28F016XS

SPECIFICATION UPDATE

Release Date: November 1996

Order Number 297553-007

Operation Delay after Power-Up and Exit from Power-Down or Reset

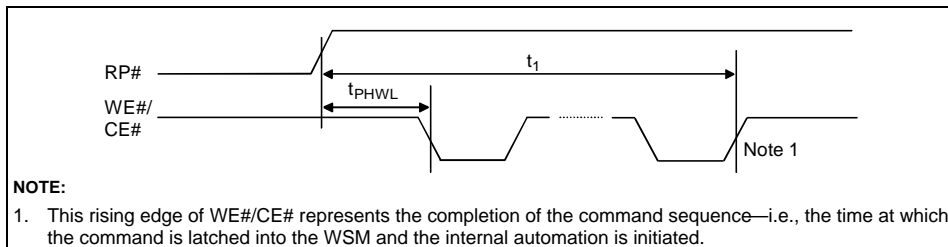
PROBLEM: With the program/erase voltage (V_{PP}) at 5V, the internal V_{PP} detector may not stabilize for up to 5 μ s (illustrated by t_1 , in the figure below) after RP# transitions inactive (high). This causes an invalid V_{PP} Level bit indication when reading the Block Status Registers and termination of program, erase or lock block operations due to invalid device V_{PP} error detection. Affected operations include Word Write (40H/10H), Block Erase (20H) and Lock Block (77H).

WORKAROUND: Upon reset, power-up, or wake-up from software sleep or hardware deep power-down, allow 5 μ s (t_1) before initiating a Write/Erase command (as listed earlier) or reading the V_{PP} Level bit of the Block Status Registers (BSR.1). The figure, *Operation Delay after Power-Up and Exit from Power-Down or Reset*, illustrates this timing requirement (t_1) in more detail.

**Example System Software Flowchart That Will Not Encounter
“Completion with Command Error” Condition**

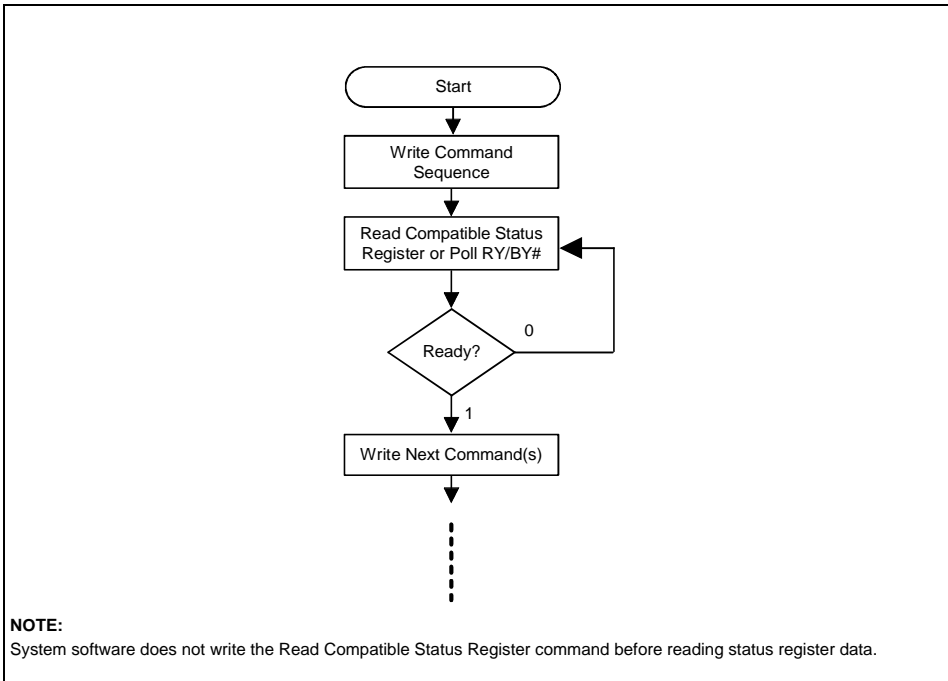
PROBLEM: Systems in which software, after initiating device automation, writes another command(s) to the device before automation completes may initiate unintended device operations.

Systems that poll the RY/BY# pin or WSMS bit (CSR.7) for “Ready” indication before writing another command to the device will not encounter this erratum. This is illustrated in the *Example System Software Flowchart*, etc. figure below, and in flowcharts 11-1 and 11-2 (without erase suspend) of the *16-Mbit Flash Memory Product Family User’s Manual*.

Erase Suspend to Read Array with Compatible Status Register

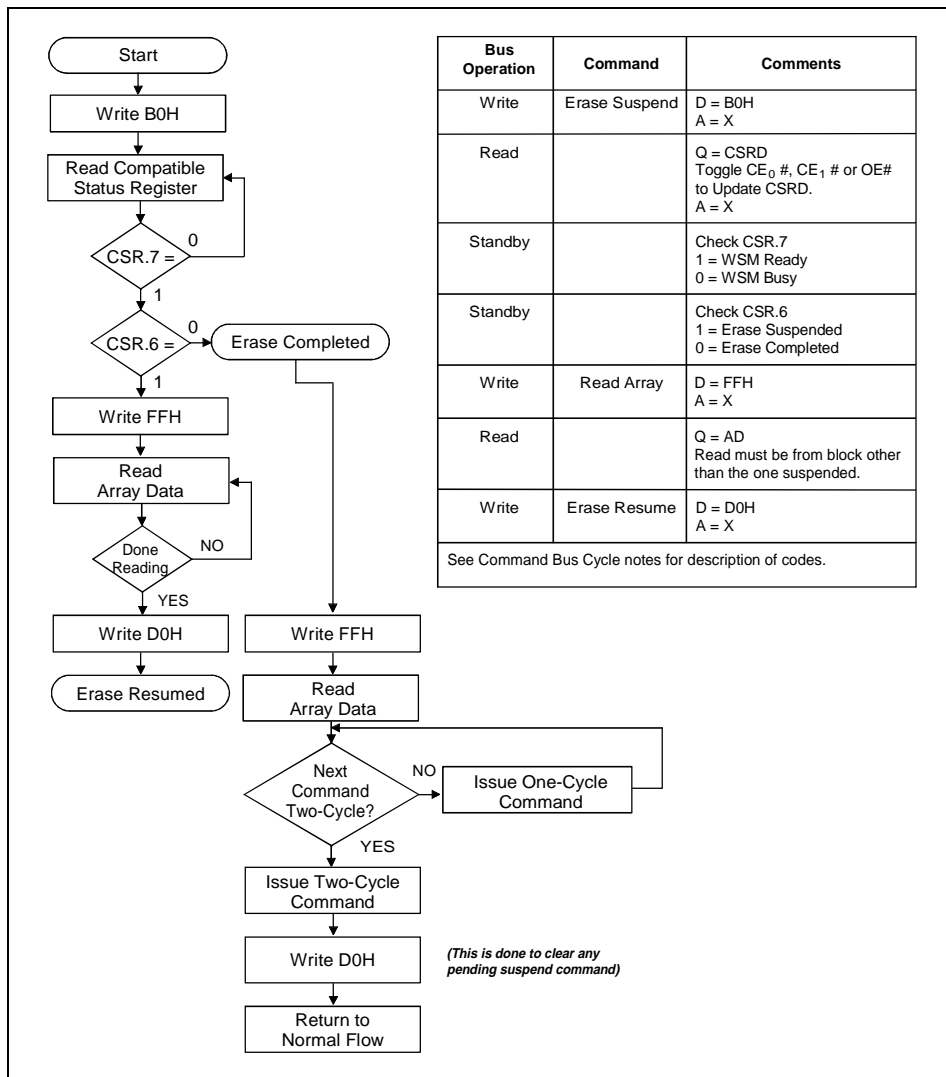
PROBLEM: If an Erase Suspend command is issued late in the Erase algorithm, it will not be recognized by 28F016XS components listed in the Affected Devices section, and erase will complete. This Erase Suspend command will **not** be discarded.

WORKAROUND: A software workaround to this erratum inserts a redundant Resume command (D0H) immediately following any Two-Cycle Command (Word Write, Block Erase, Lock Block, or Upload Status Bits) in the Erase Suspend flowcharts. Modified Erase Suspend to Read Array flowcharts (Figures 11-3 and 11-12 of the *16-Mbit Flash Memory Product Family User's Manual*) detailing this workaround are shown in the *Erase Suspend to Read Array with Compatible Status Register* and *Erase Suspend to Read Array with Extended Status Register* figures, which follow. This erratum results in the *Erase Suspend with Compatible Status Register* flowchart being incompatible with the 28F008SA *Erase Suspend* flowchart.

Read Timing Waveform (SFI Configuration = 2, Alternate-Bank Access)

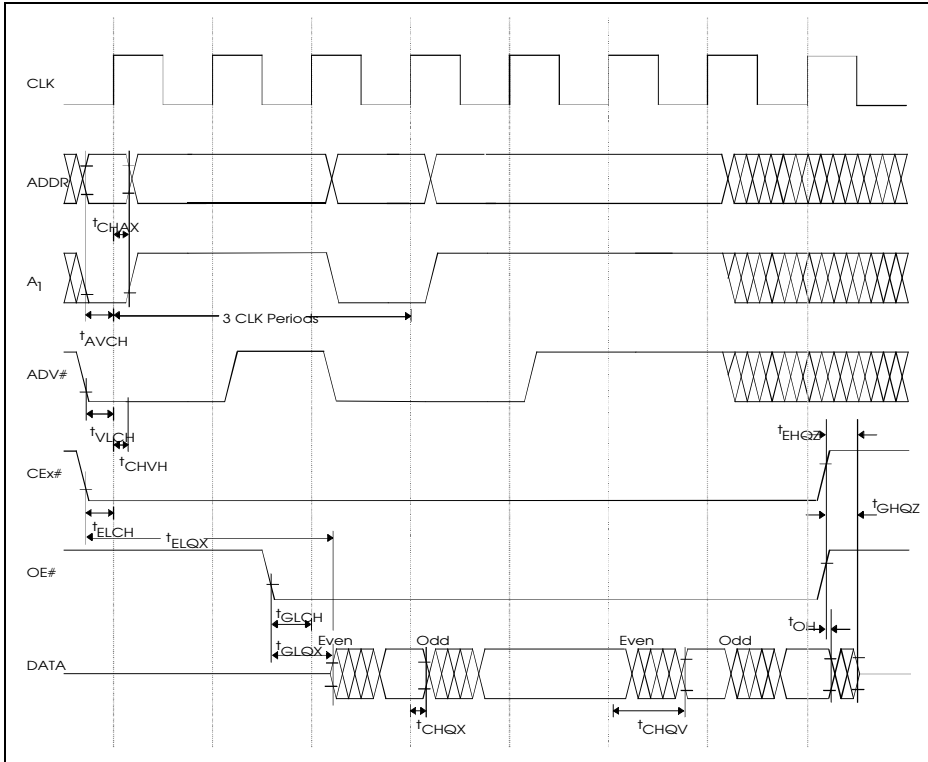
PROBLEM: An additional wait-state is required between consecutive Same-A₁ accesses for components listed in the Affected Products section.

WORKAROUND: A new Same-A₁ (same bank) address cannot be placed on the bus until after the rising clock edge upon which data for the previous Same-A₁ (same bank) access is driven out of the 28F016XS flash memory device. This rising CLK edge will occur a number of clock cycles equal to the SFI Configuration setting after latching the address from the previous Same-A₁ access. Addresses are latched upon sensing ADV# low in conjunction with a rising CLK edge.

The Read Timing Waveform, which follows, illustrates a modified version of the read timing waveform, Figure 11 in the *28F016XS 16-Mbit (1 Mbit x 16, 2 Mbit x 8) Synchronous Flash Memory Datasheet*, which illustrates this burst access sequence described in the previous paragraph. Similarly, this condition applies to all SFI Configurations.
